Proposal for the 03 series of amendments to UN Regulation No. 55 (Mechanical couplings)

Submitted by experts from Austria and the Netherlands *

The text reproduced below was jointly submitted by Austria and the Netherlands to amend UN Regulation No. 55. It clarifies the need to have a support device for centre axle trailers, independent of the type of coupling device. The modifications to the current text of the UN Regulation by document ECE/TRANS/WP.29/GRSG/2023/18 are marked in “bold black“ for new or strikethrough for deleted characters. The modifications made by this document are marked in “**(bold) blue**” for new or strikethrough for deleted characters.

Example of an arrangement of the approval mark

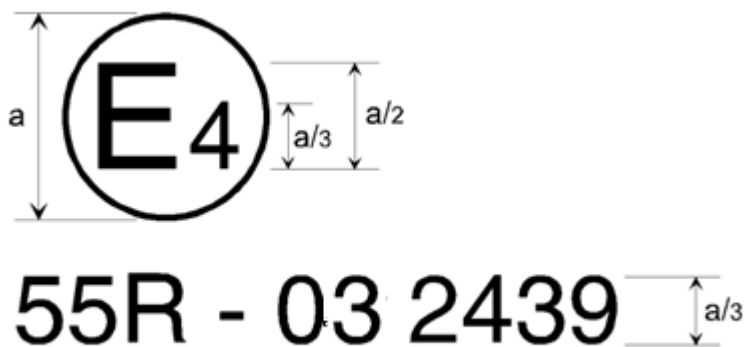
Annex 3, amend to read:

The mechanical coupling device or component or vehicle bearing the approval mark shown above is a device or component approved in the Netherlands (E 4), under approval number 2439, meeting the requirements of the 03 series of amendments to this Regulation.
